# ARNESON GARDENS EXIT ROAD CONFIGURATION

City Council Meeting  
February 1, 2017

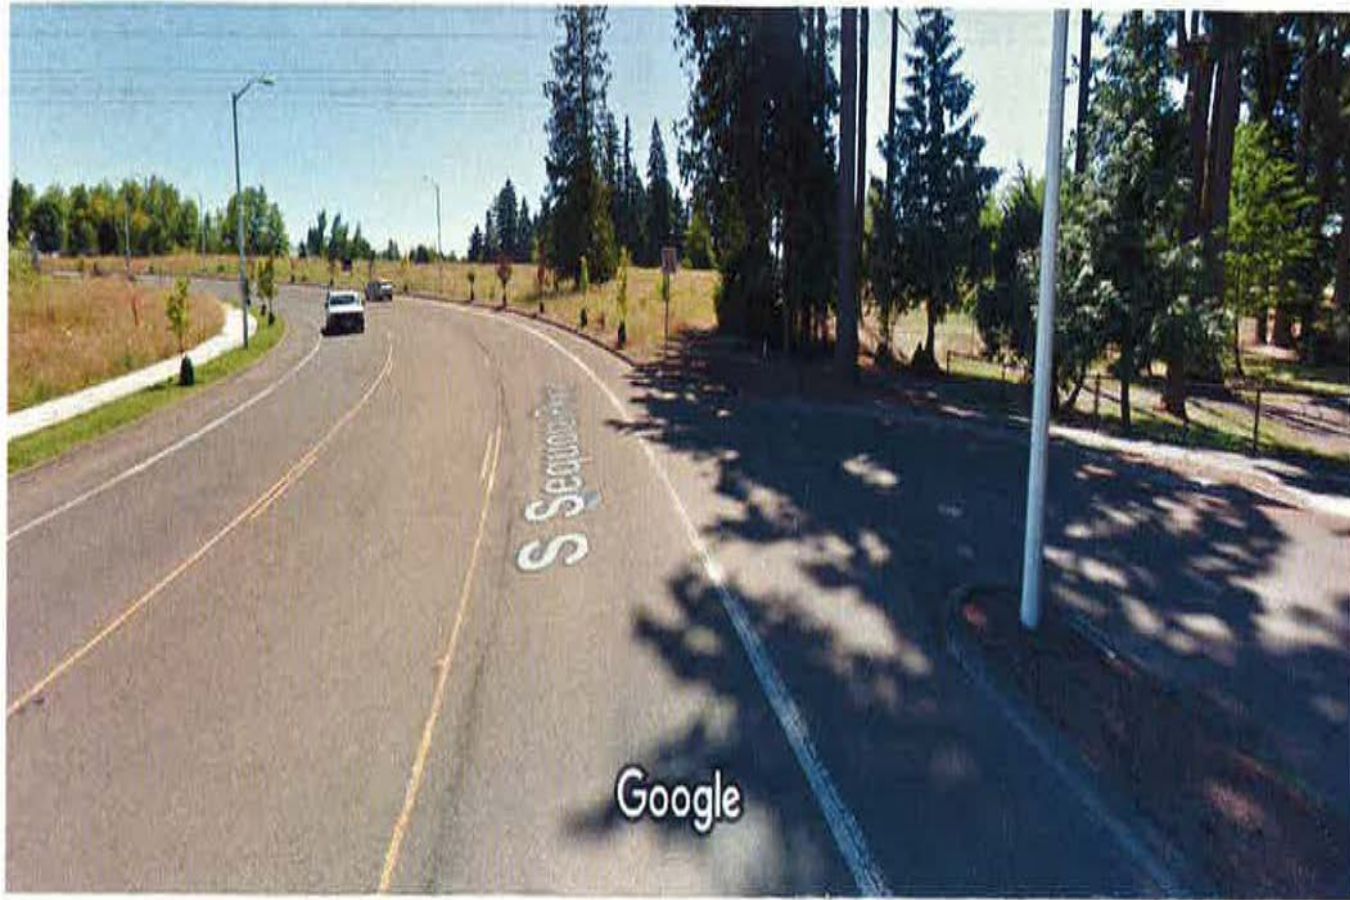
Question: When was the exiting layout approved?

Question: Why was this allowed?

Question: Can Sequoia Grove Apartments block access to the park exit?

Question: This is a gated community. Won't that affect the public's ability to exit the Arneson Gardens parking lot?

Question: Will the Sequoia Grove residents have access to a separate entrance into Arneson Gardens?

Answer: The exiting layout currently under construction is the design approved at the time the project was approved

Answer: When the apartments were being considered, one of the challenges was the placement of the driveways, which need to be no closer than 200 feet apart. Because the City park exit and the Sequoia Grove apartment access roads would be too close together, the City park exit and the Sequoia Grove driveway were realigned to share the same street access.

Answer: No. This issue was addressed at the November 10, 2015 Pre-application meeting at which the applicant agreed to an access easement.

Answer: No. The Sequoia Grove apartments will be a gated community but the gate will be to the right of those persons exiting the park (cars exiting the park will turn left onto the exit road) and so will not interfere with public exiting from the Arneson Gardens parking lot.

Answer: No. A fence will surround Arneson Gardens and the access points to the park will remain the same. Residents of Sequoia Grove will have the same access that every member of the public enjoys – no more and no less.
